Town of Parker Community Development Department
 Development Review Division
 Attention: ~~Carson Byerhof~~ *Ashley Chasez*

Application Type: **Site Plan**
 Status: **First Referral**
 Application Name: Douglas 234 F6 AMD 1 L4 - Dunkin Donuts
 Case/AP#: **SP22-041**
 Referral Received: June 13, 2022
 Comments Due: July 13, 2022

Narrative: The applicant, Ethos Architecture, is proposing a 2,108 sq. ft. drive through donut store. The site is located northeast of Hess Road and Chambers Road.

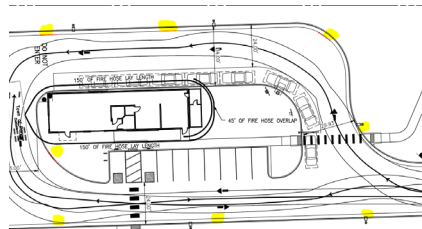
This submittal does not provide for this requirement of the code. Per the requirements of the code, the fire code official is allowed to increase the dimension of the 150 feet provided that the applicant meets Exception 1.1 of this

section... “The building is equipped throughout with an approved automatic sprinkler suppression system installed in accordance with section 903.1.1, 903.1.2, or 903.3.1.3. The applicant will need to address this issue when resubmitting.

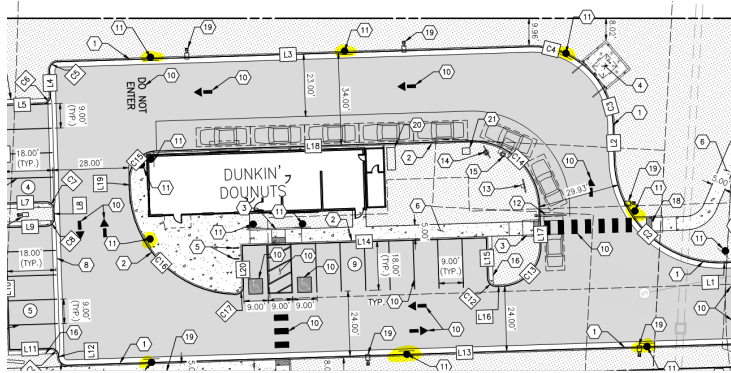
5. The applicant shall provide NO PARKING – FIRE LANE signage for any portion of the access where the 24-foot clear width requirement cannot be met; areas that are required to have this signage are located on both the north and sides of the building. See below for areas highlighted in yellow: **Not satisfied; see below for locations specific to NO PARKING – FIRE LANE signage. Provided double arrows in all cases and address when resubmitting: Satisfied; the applicant has located signage on the site plan that mimics the locations shown below. The assumption is that this is the required fire lane signage. In the event that it is not, the applicant is still required to install as noted below:**

The site plan provided below indicates the signage that was added (as documented above). Inspection team personnel will use this plan to confirm fire lane signage throughout the site.
